DATE: 3-1-16

APPLIES TO: This service bulletin applies to certain Star model Emergency Response Vehicles built by Spartan Motors USA, Inc. between February 1, 2015 and January 13, 2016.

CONDITION: C-channel for body structure did not meet specification.

CORRECTION: Install reinforcement plates. Due to the customized nature of the reinforcement plates, contact Customer Product & Support for the appropriate kit.

FIG. 6-1

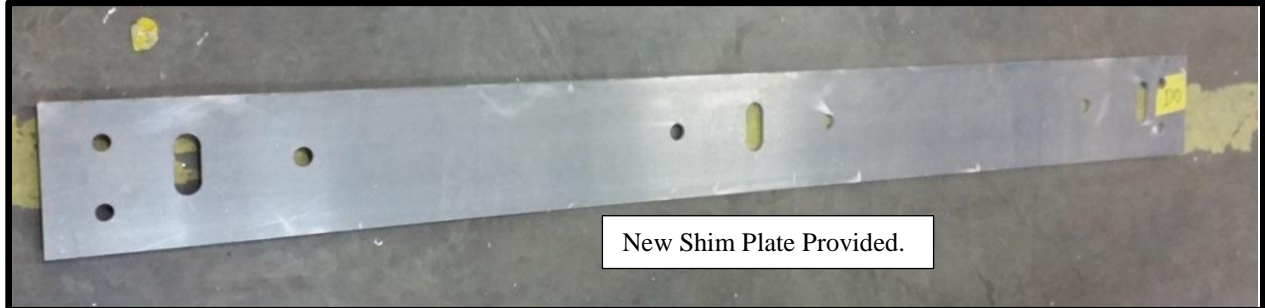
- Place reinforcement plates into place using a tilting motion to clear bolt heads on frame. Long body bolts should extend through slots in shim. Refer to FIG. 6-1, 6-2, and 6-3.

NOTE: Actual plate size and hole configuration may differ from FIG. 6-1.

FIG. 8-2

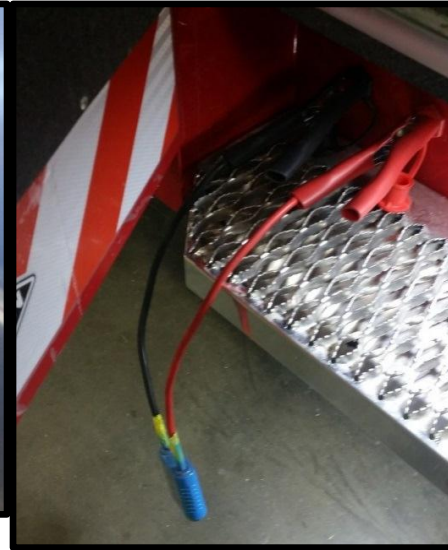
11. Install surge protector at power point of truck (battery jumper studs). Refer to FIG. 8-1 and 8-2.
